Project Name: Spot Bar
Project Address: 859 Randolph Avenue
Suite #/Campus: N/A
City Name: St. Paul
Applicant: Bruce Pastorius, Collective Carpentry

<p>SPOT BAR 8,59 RANDOLPH AVE ST, PAUL MN 55102 MERIDITH OTOOLE</p>	<p>SITE PLAN SCALE: 3/4" = 1'-0"</p>
--	---

CITY OF ST. PAUL
REVIEWED FOR CODE COMPLIANCE
ARCHITECTURAL V-21-2094
DATE 12/13/2021 MD
STRUCTURAL _____
DATE _____

REVISED PLAN 12/20/2021:
REDUCED SIZE OF PROPOSED
DECK TO 20' x 20'

DECK SIZE

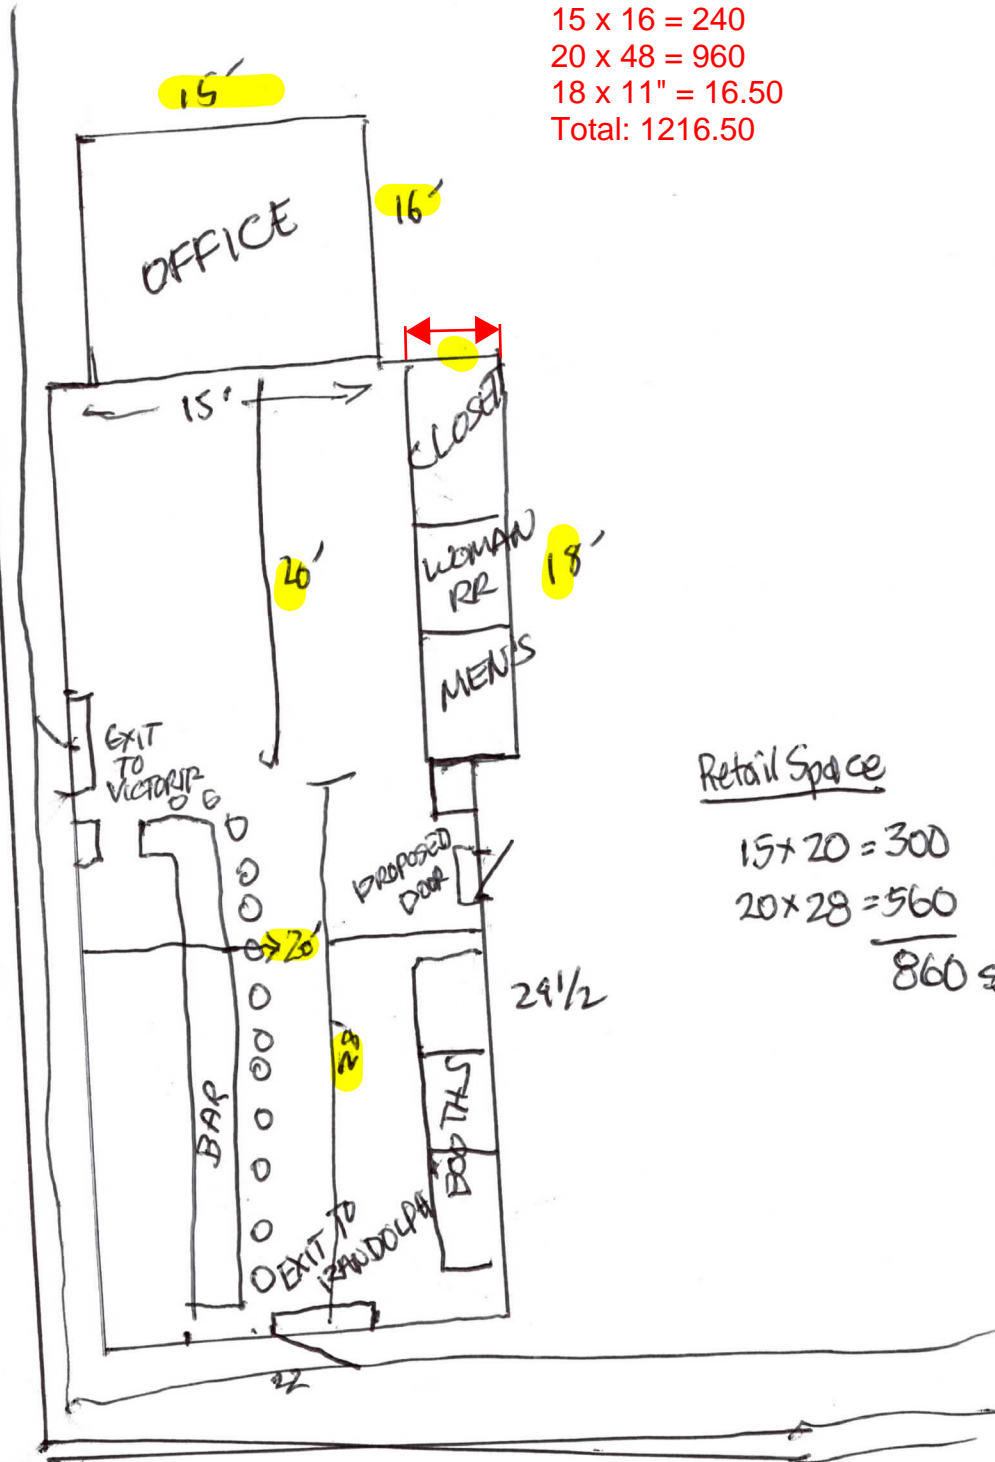
CHANGED TO 20x20 DECK WHICH IS SMALLER THAN ORIGINAL DECK PLAN, OK FOR PLAN REVIEW, STILL NO SAC OWED.

SPOT BAR 859 RANDOLPH AVE SP. PAUL MN 55102 MERIDITH JOOLE	OUTDOOR LOUNGE 8'x19' DECK 10'x30' DECK 37 LF PRIVACY FENCE P.I
---	---

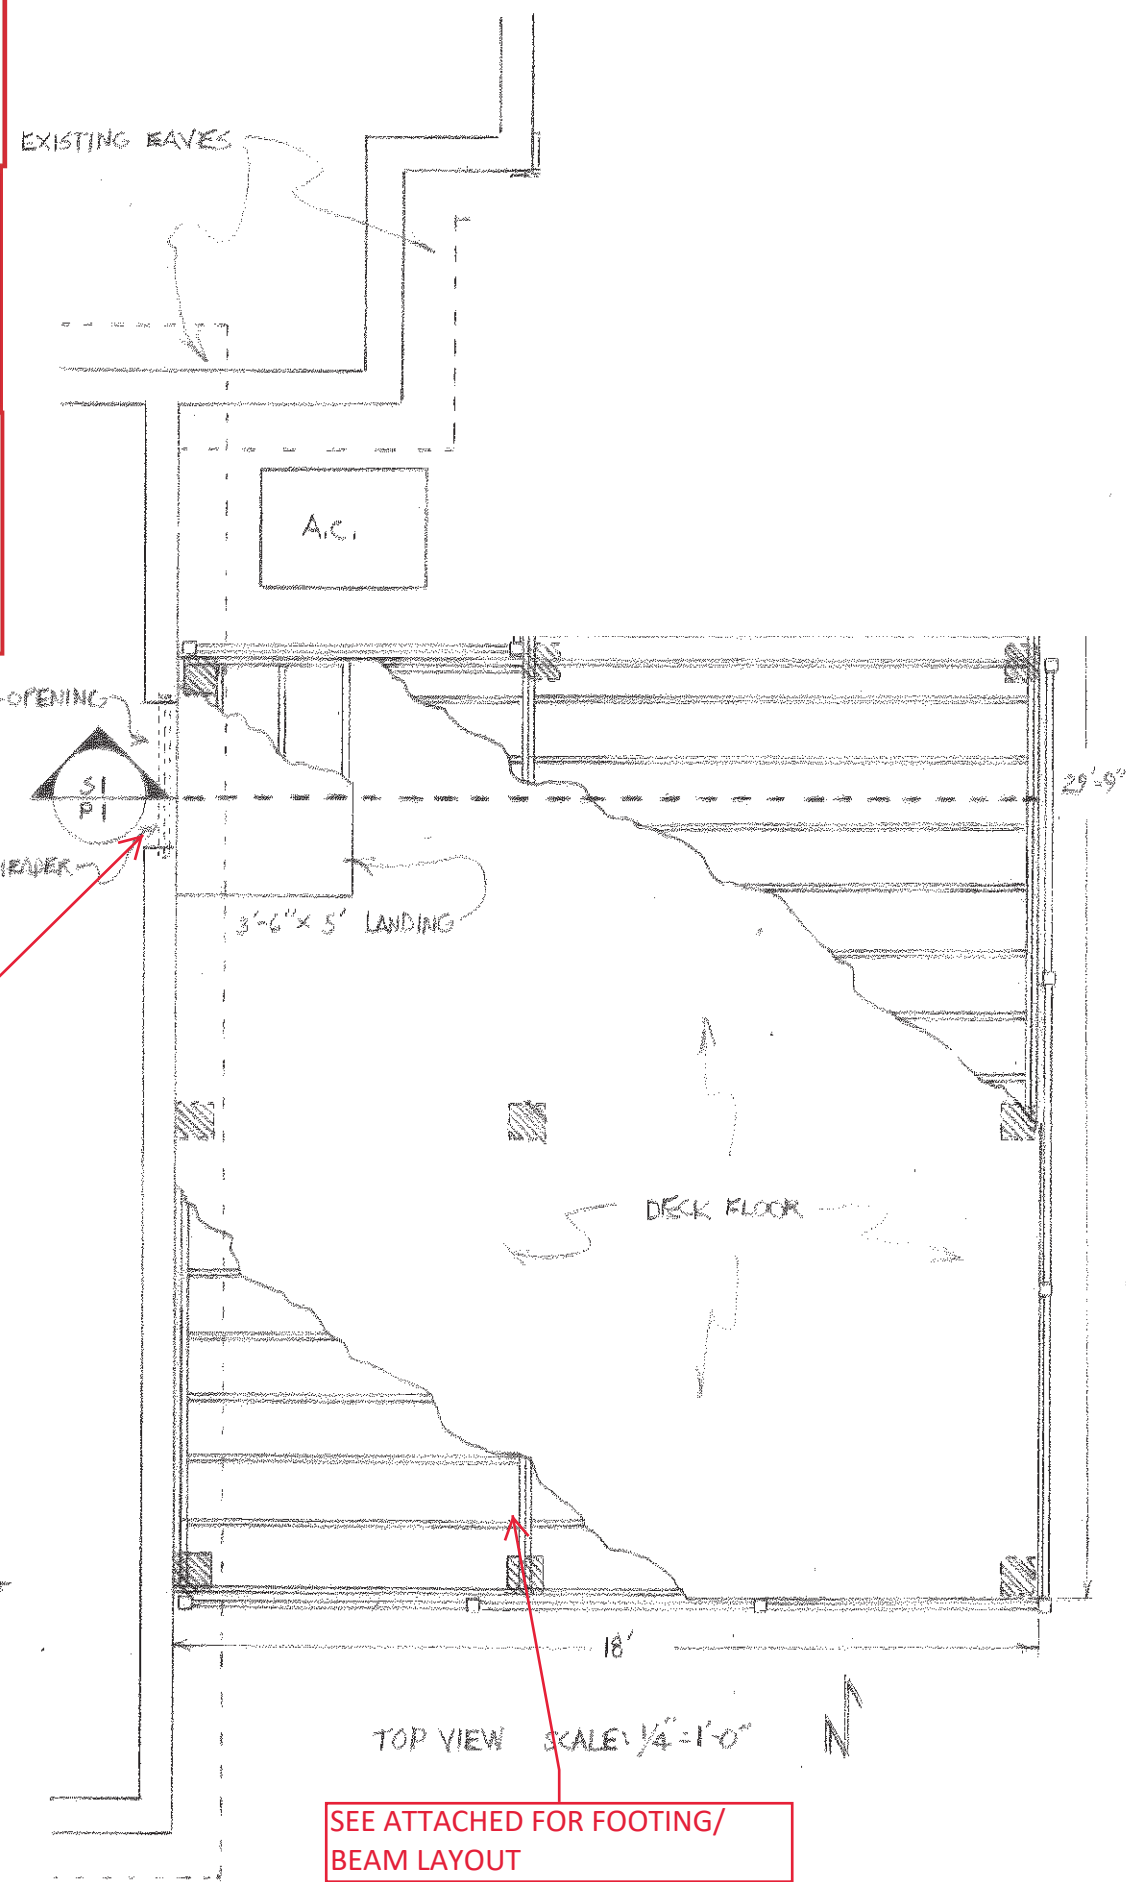
MN ACCESSIBILITY CODE COMPLIANCE REQUIRED. INSTALL EXACTLY PER CODE. ALL ERRORS MUST BE CORRECTED.

SEE ATTACHED FOR FOOTING/BEAM LAYOUT

NO LANDING HERE DECK TO BE BOUT 22" OFF THE GROUND AND NO MORE THAN 3/4" BELOW THE INTERIOR FLOOR SURFACE FOR ACCESSIBILITY.

SEE ATTACHED SEATING PLAN, OCCUPANT LOAD OF 20X20 DECK WITH TABLES/CHAIRS IS LESS THAN 50' DOOR SWING CAN GO EITHER WAY.

SPOT BAR
259 RANDOLPH
ST PAUL MN 55102
MEREDITH OTOOLE

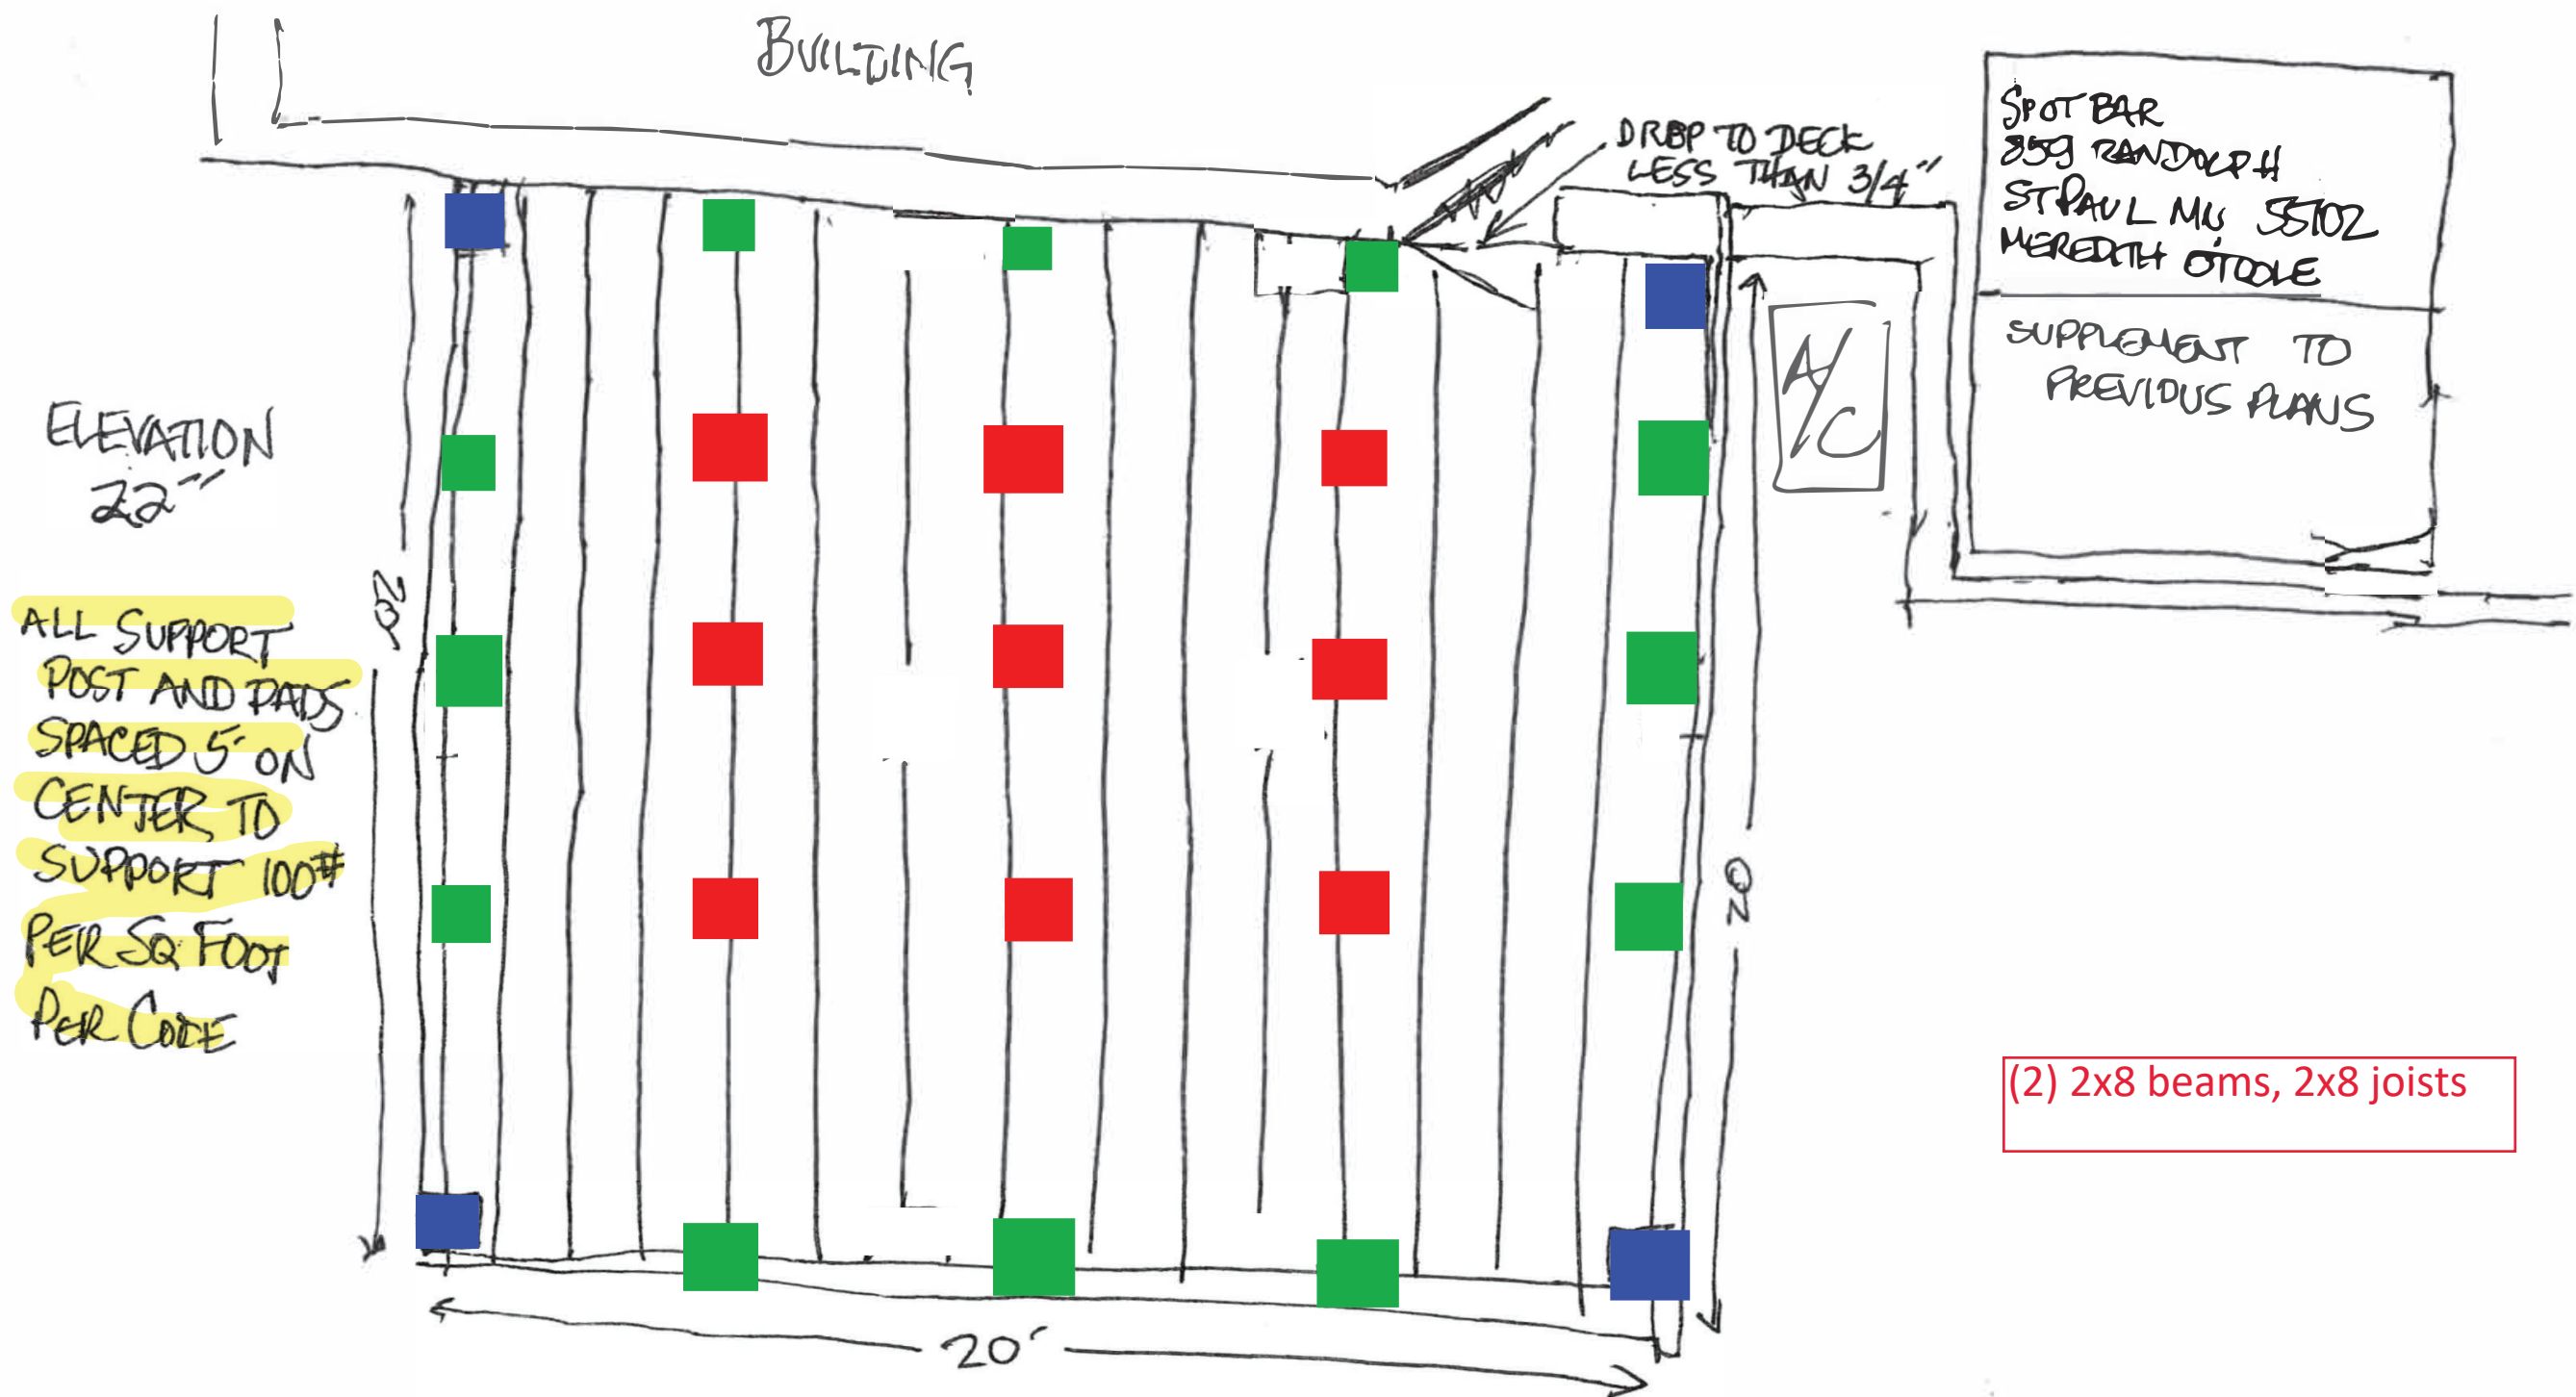
ALTERNATE ACCEPTABLE FOOTING LAYOUT: FOR A DECK USING 8"X8" PRECAST FOOTINGS, TRIBUTARY AREA FOR EACH FOOTING WOULD BE A MAXIMUM OF 9 SQUARE FEET (FOOTINGS WOULD NEED TO BE IN PLACE EVERY 3' FEET IN A GRID PATTERN MINIMUM OR EQUIVELANT).

ALL SUPPORT
POST AND PADS
SPACED 5' ON
CENTER TO
SUPPORT 100#
PER SQ FOOT
PER CODE

SUPPLEMENT TO
PREVIOUS PLANS

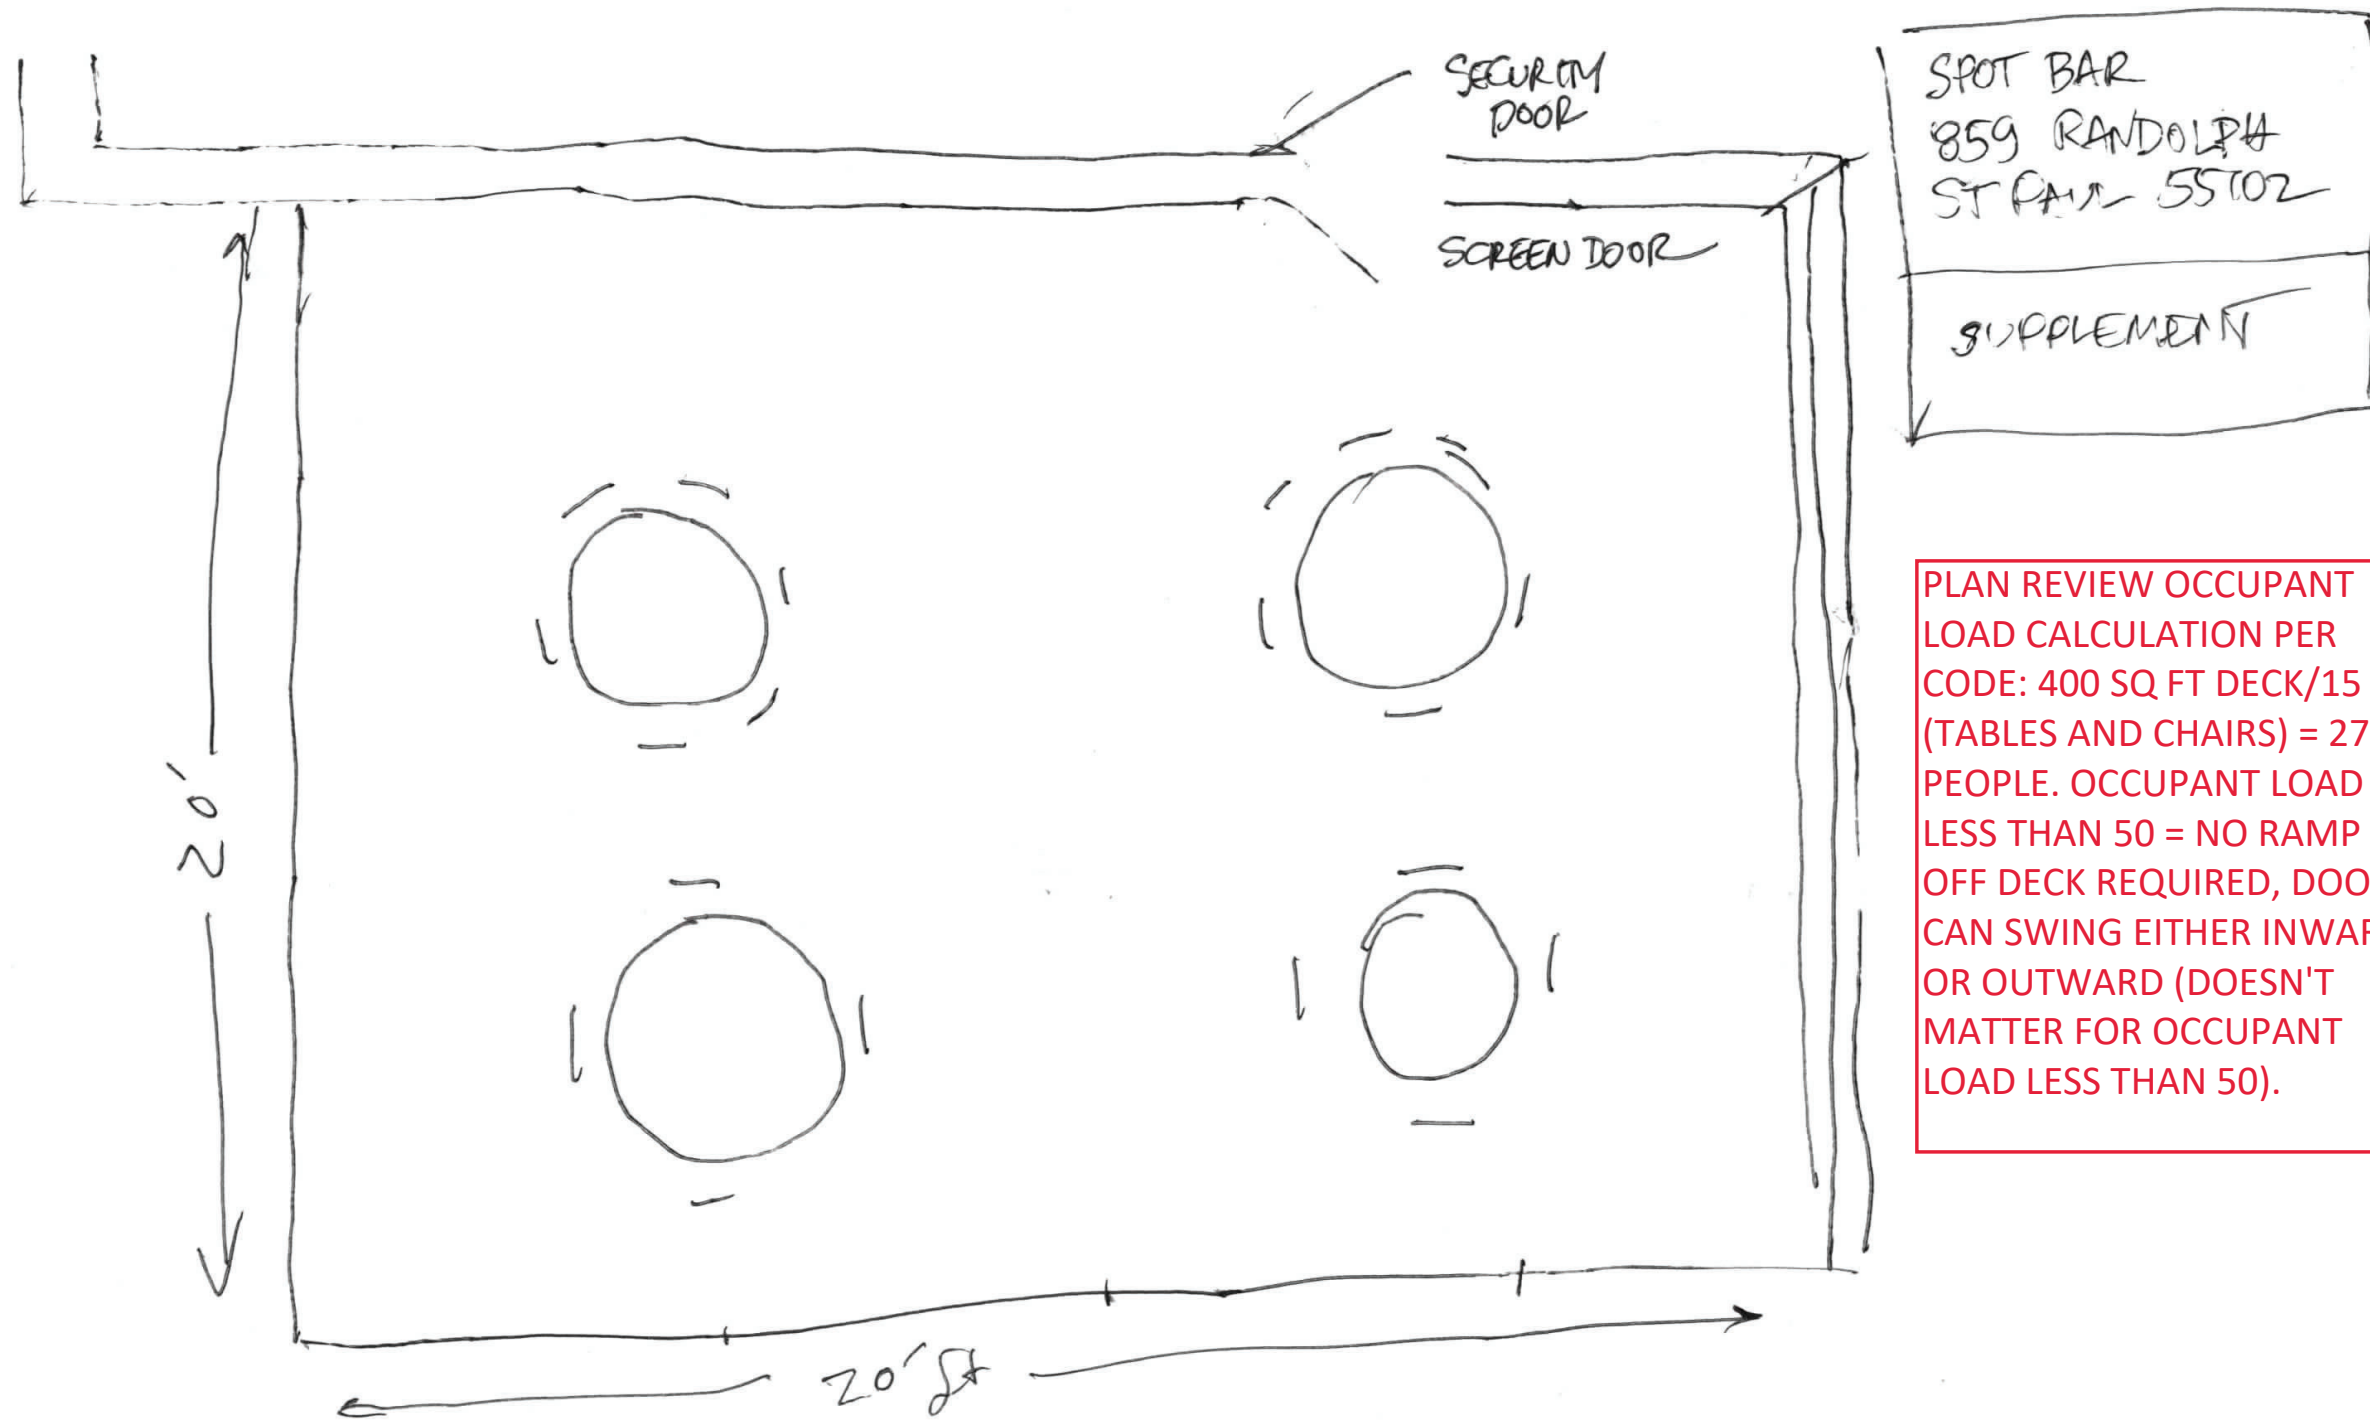
- = RED FOOTINGS; SUPPORTING 2500 LBS, SIZE 14"X 14" PAD FOOTING MINIMUM
- = BLUE CORNER FOOTINGS, SUPPORTING 625 LBS, 8" X 8" PAD FOOTING MINIMUM
- = GREEN OUTER FOOTINGS, SUPPORTING 1250 LBS, 11"X 11" PAD FOOTING MINIMUM

FENCE/RAILING TO ENCLOSE ENTIRE DECK AND BE ATTACHED TO DECK

PLAN REVIEW OCCUPANT
LOAD CALCULATION PER
CODE: 400 SQ FT DECK/15 OL
(TABLES AND CHAIRS) = 27
PEOPLE. OCCUPANT LOAD
LESS THAN 50 = NO RAMP
OFF DECK REQUIRED, DOOR
CAN SWING EITHER INWARD
OR OUTWARD (DOESN'T
MATTER FOR OCCUPANT
LOAD LESS THAN 50).
